**Amendments to the Drawings:**

## ANNOTATED SHEET SHOWING CORRECTIONS

Fig. 1

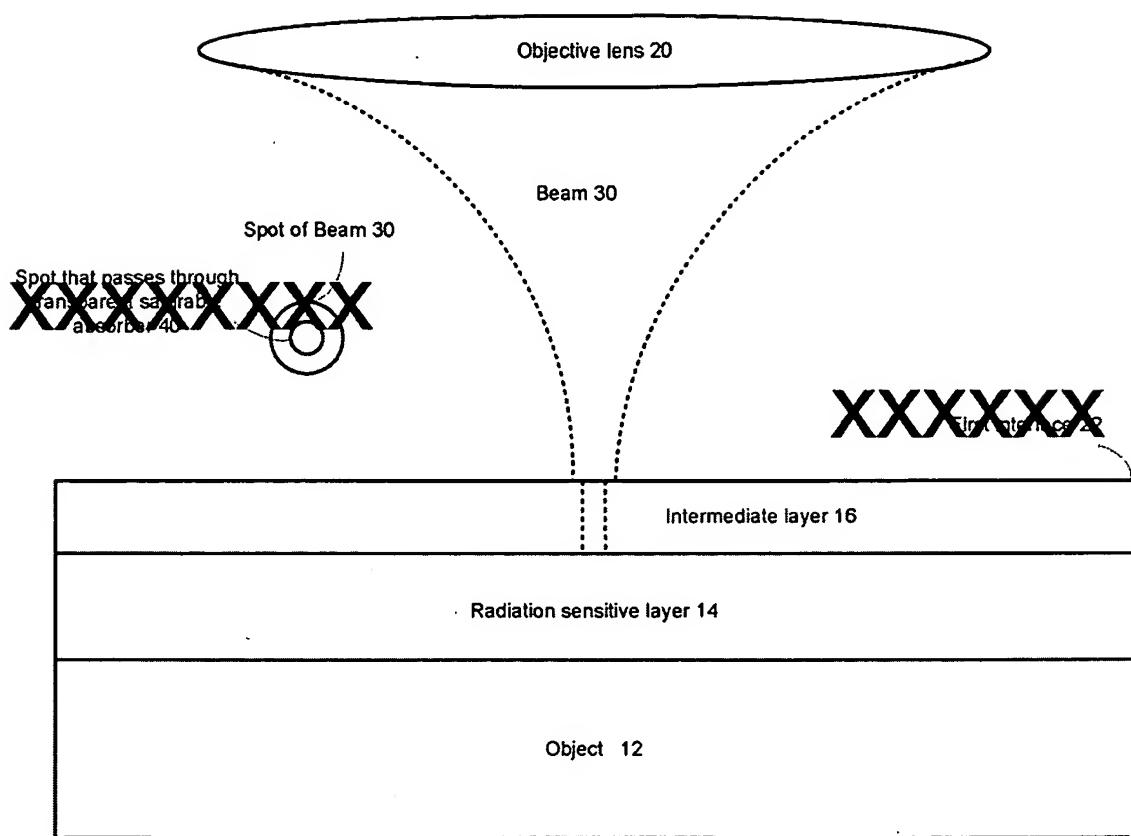
In Figure 1, the top view of the spot formed by the laser beam (which the examiner indicated was confusing) has been eliminated, as has the reference to interface 22, which was not include din the specification.

**Fig. 2**

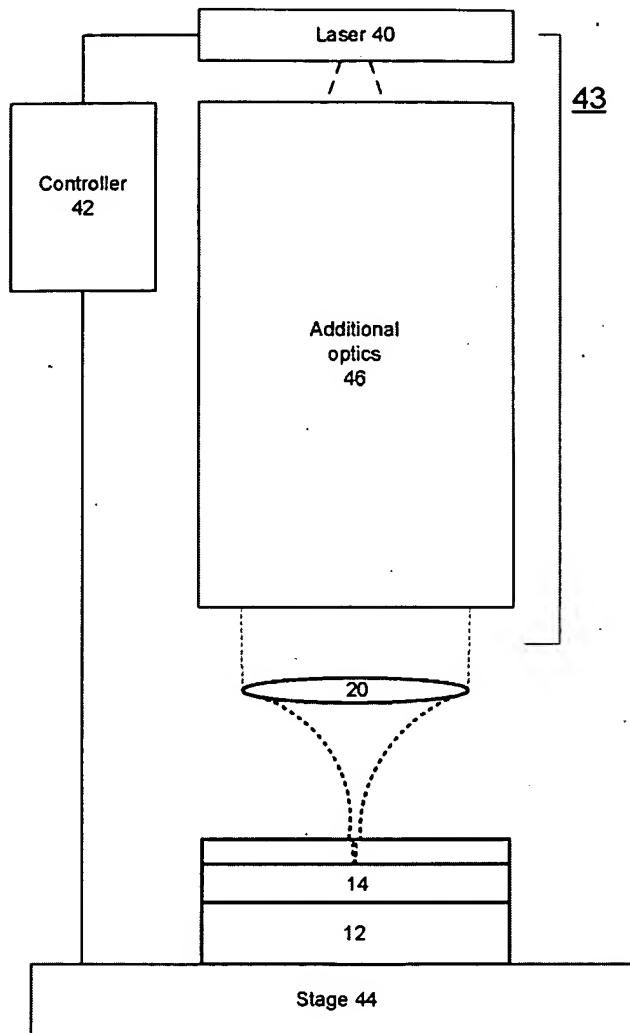
In Figure 2, previously omitted element 43 has been added.
